Well Name: ANGEL PEAK 1	Well Location: T27N / R10W / SEC 1 / NESE / 36.602405 / -107.841722	County or Parish/State: SAN JUAN / NM
Well Number: 20S	Type of Well: OTHER	Allottee or Tribe Name:
Lease Number: NMSF077384	Unit or CA Name:	Unit or CA Number:
US Well Number: 3004532431	Operator: HILCORP ENERGY COMPANY

Type of Submission: Notice of Intent	Type of Action: Plug and Abandonment
Date Sundry Submitted: 03/05/2025	Time Sundry Submitted: 08:17
Date proposed operation will begin: 03/26/2025

**HILCORP ENERGY COMPANY**  
**ANGEL PEAK 1 20S**  
**P&A NOI**

### Notice of Intent – Plug and Abandonment

**ANGEL PEAK 1 20S - CURRENT WELLBORE SCHEMATIC**

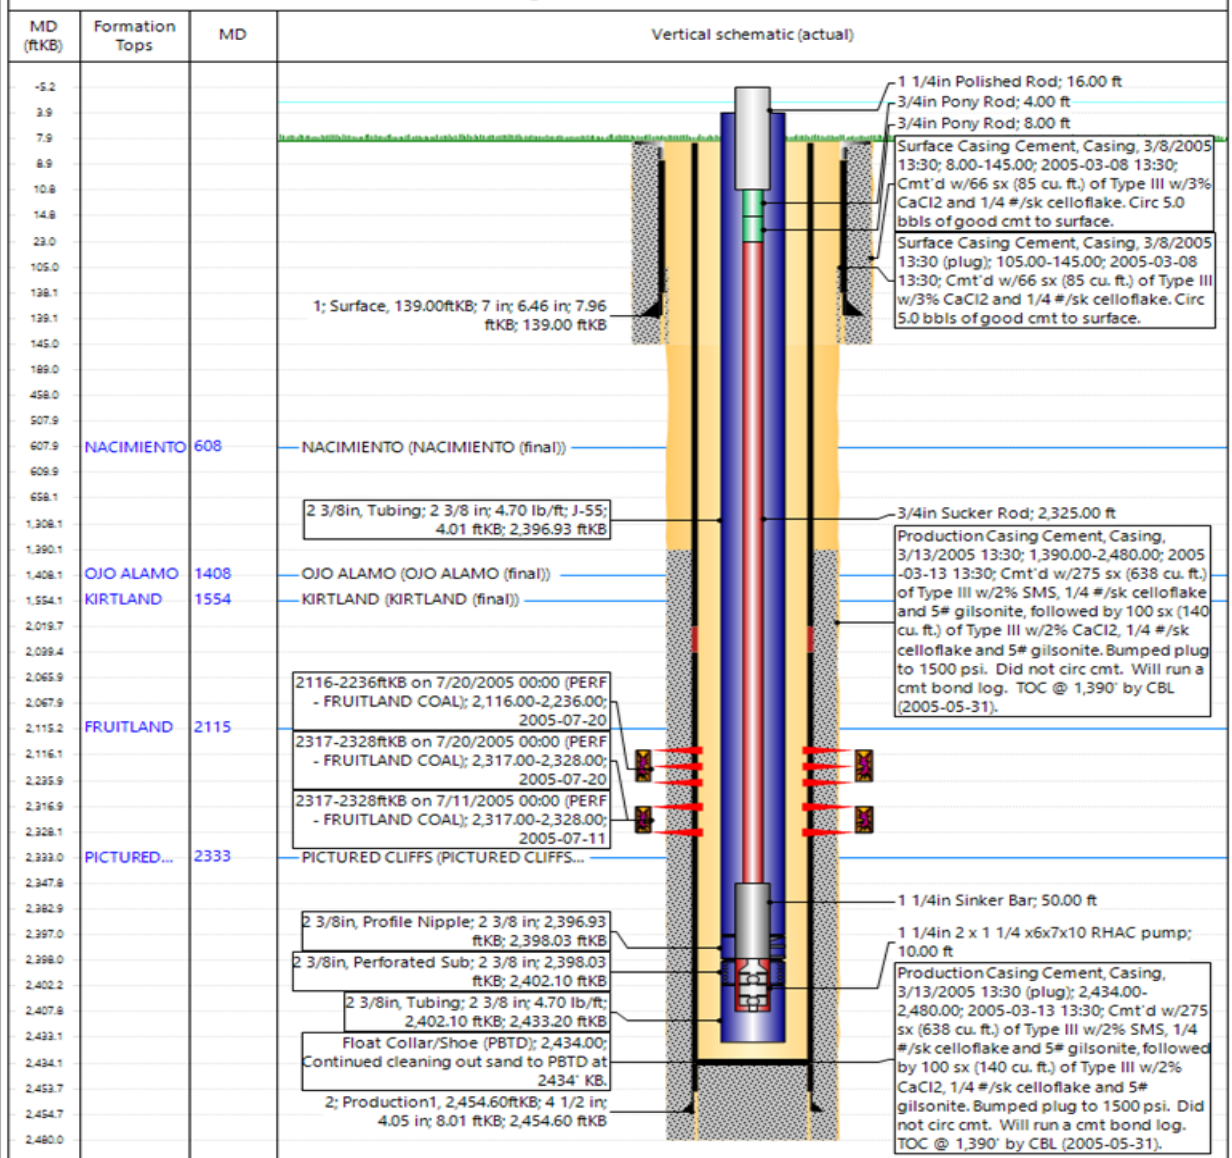
-The Perforation Record in the Well Completion form identifies well perforations installed in the 2052' – 2097' interval. These perforations are not included in the P&A well bore schematic and would affect the Plug 1 placement.

**ANGEL PEAK 1 20S - PROPOSED WELLBORE SCHEMATIC**

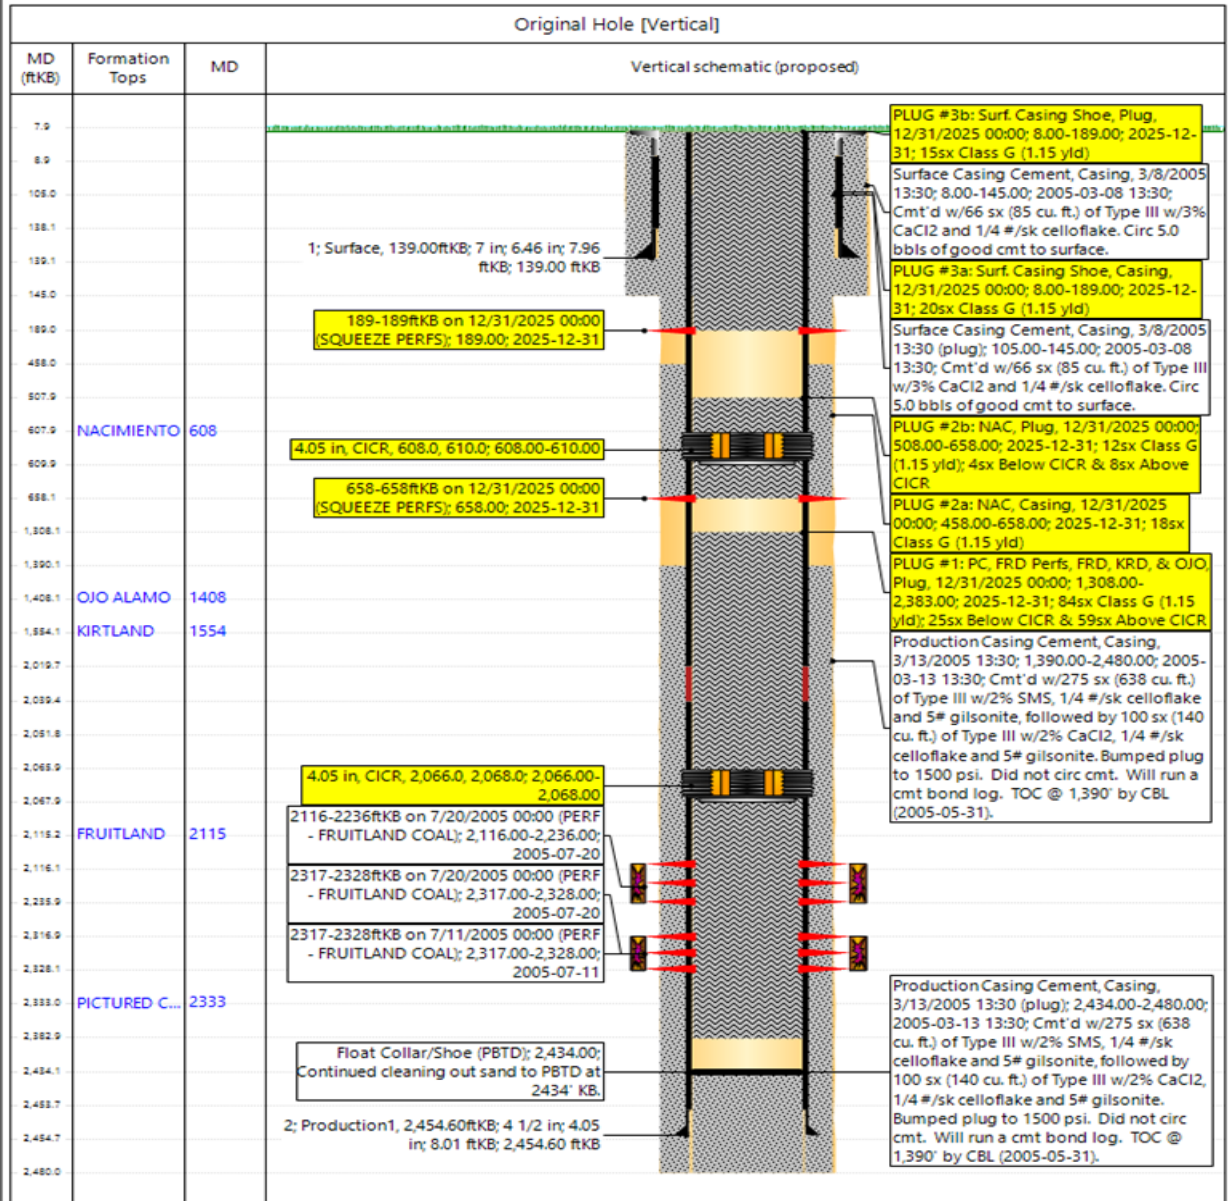
-Plug 1: There are multiple depths given for the outside TOC. In the Well Completion form the TOC is given as 300'. In a note in the P&A well bore schematic the TOC is given as 1390'. In the CBL found in the OCD website the BLM geologist picks 1440' for the TOC. The correct TOC should be determined and used to completely and properly cover the Ojo Alamo.

-The TOC of the inside and outside portion of Plug 1 should be 1277' to account for the BLM geologist's pick for the Ojo Alamo.

Plug 2 and Plug 3 are acceptable as described.

Created By	Condition	Condition Date
mkuehling	NMOCD agrees with BLM on formation tops - concerning perforations left out of noi please correct in your subsequent - you may need to adjust where you are putting cement retainer and add more cement below retainer - Notify NMOCD 24 hours prior to moving on - monitor string pressures daily report on subsequent - CBL is in the log file	3/19/2025

1. Plugging operations authorized are subject to the attached "General Requirements for Permanent Abandonment of Wells on Federal and Indian Lease."
2. The following modification to your plugging program is to be made:
  - a. See attached BLM Geology Report. An updated procedure and wellbore schematic may be required.
3. **Notification:** Farmington Office is to be notified at least 24 hours before the plugging operations commence at (505) 564 7750.
